TOWN OF NISKAYUNA
Planning Board and Zoning Commission
Agenda
January 9, 2023 7:00 PM

REGULAR AGENDA MEETING

AGENDA STATEMENT

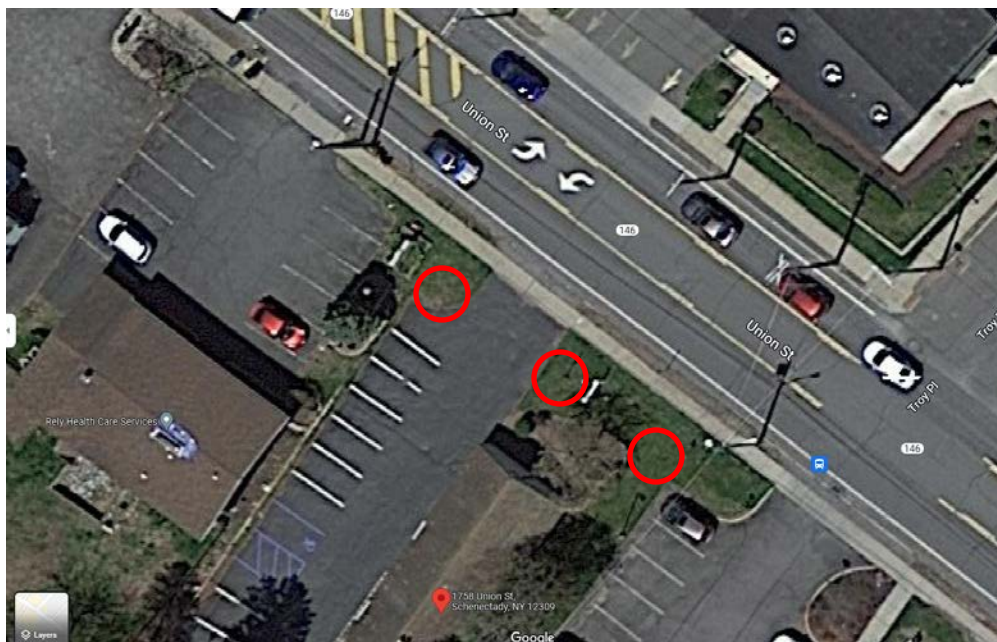
Because this project is an improvement to the area and the tenant change reduces parking demands and traffic generation – the Planning Department has proposed a tentative resolution for site plan approval. Two things to discuss with the applicant are whether or not street trees could be added to Union St to help provide shade to walkers and mitigate the impacts of climate change – and whether or not to add a condition to repair/replace the asphalt connection to Union St and the sidewalk along the property line should be required.

PAVEMENT / SIDEWALK Repair / replace

AREAS FOR STREET TREES

1. If proposed signage complies with Zoning Code it can be reviewed and approved by the Planning Department. Any waivers or special signage will require the signage to be approved by the Planning Board.
2. Applicant shall explore planting street trees in the green areas adjacent to Union St and submit a planting plan of findings to the Planning Department / Tree Council.
3. Applicant shall repair / replace asphalt and sidewalk that serves this property according to the specifications of Schenectady County.

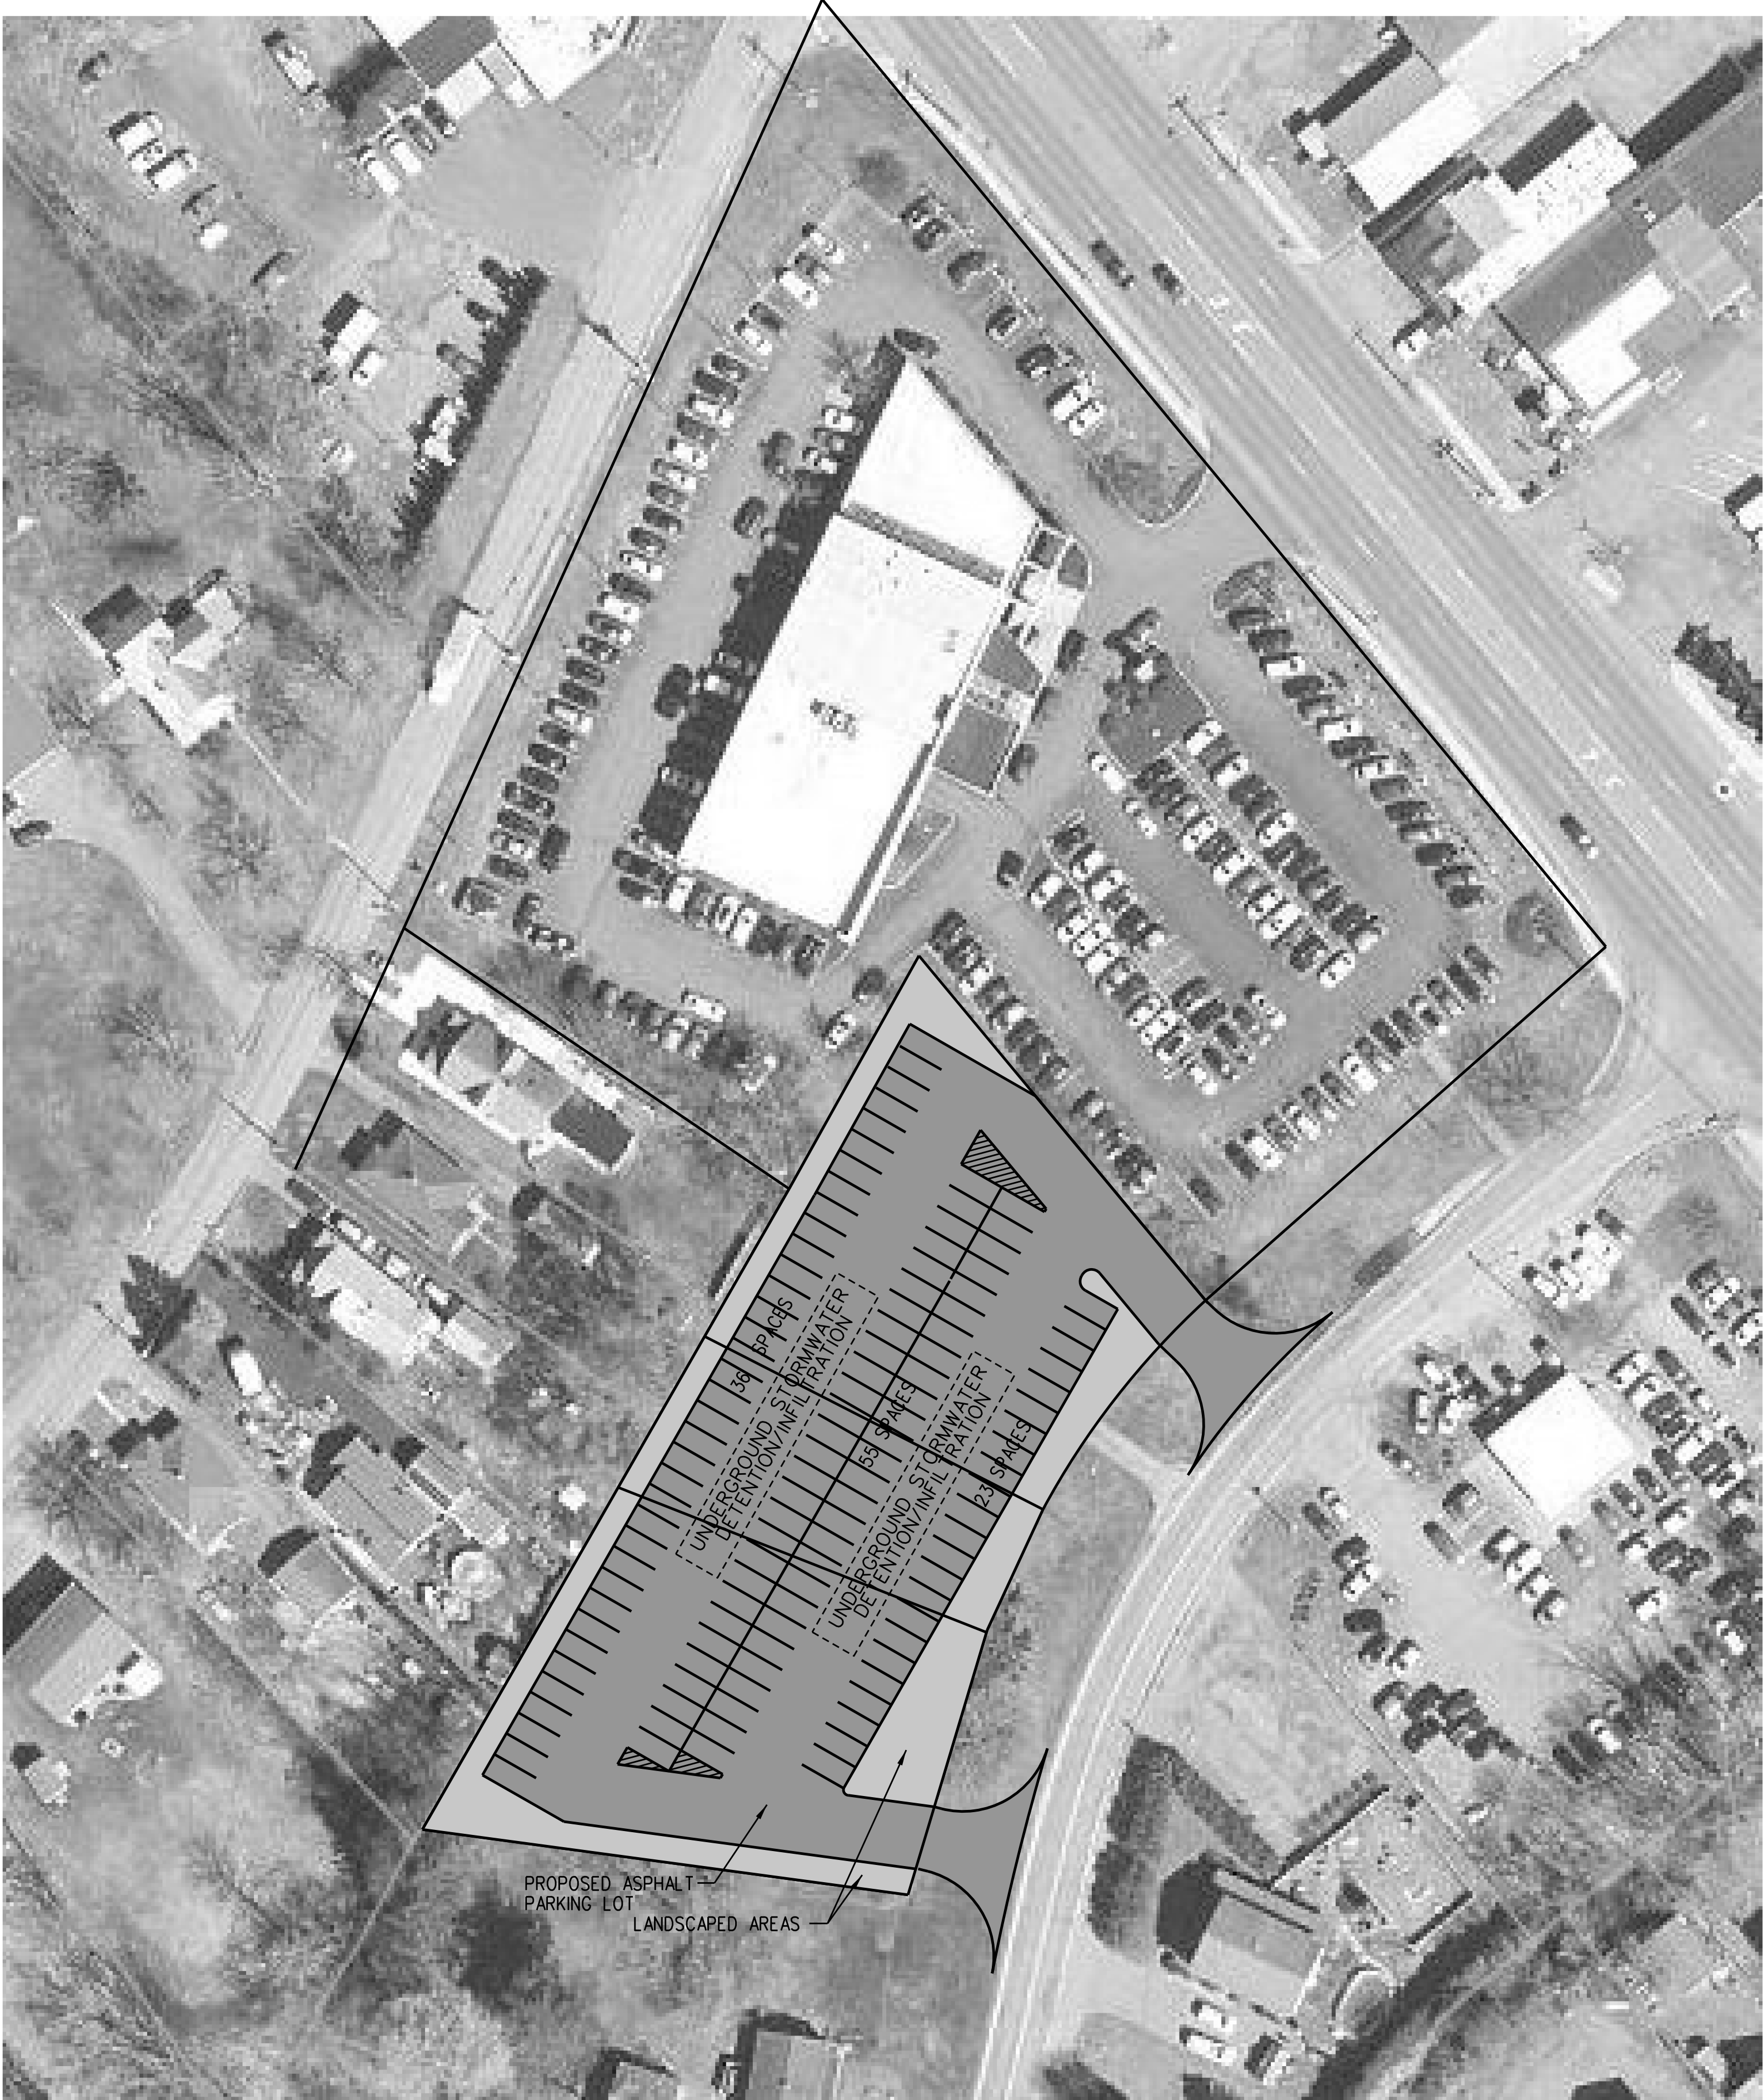
The initial review from the Planning Department indicates that, should this application proceed, the applicant will need to submit a special use permit to conduct the Automobile sales use upon the three adjacent lots which are currently single family residential or vacant/treed lots. There

are also strict buffering requirements for unenclosed uses adjacent to residential homes, as this proposal would be : 220-21 (B) and 220-16 (A) (3) (a).

This application will require an Environmental Assessment Review. In their initial look at this project, the Conservation Advisory Council had some immediate concerns about the additional impervious space and the impact to the adjacent residential neighborhood. Their preliminary comments are:

1. The proposal would be detrimental to the residential nature of the affected neighborhoods. The Northwest side of S Fagan Ave is currently all residential within the Town of Niskayuna, with the exception of a substantial buffered portion of the existing KIA parking lot on State St. This proposal would leave one residential home sandwiched between the Town of Colonie and the new proposed parking lot and disrupt the resident character on both S Fagan and S Amherst.

2. The CAC had concerns over the loss of green space and the negative impact the additional asphalt could have on the adjacent homes on S Amherst Ave. They were particularly concerned about the negative impacts of increases in temperature due to the large increase in asphalt.

4. The CAC was concerned this proposal goes against the Comprehensive Plan.
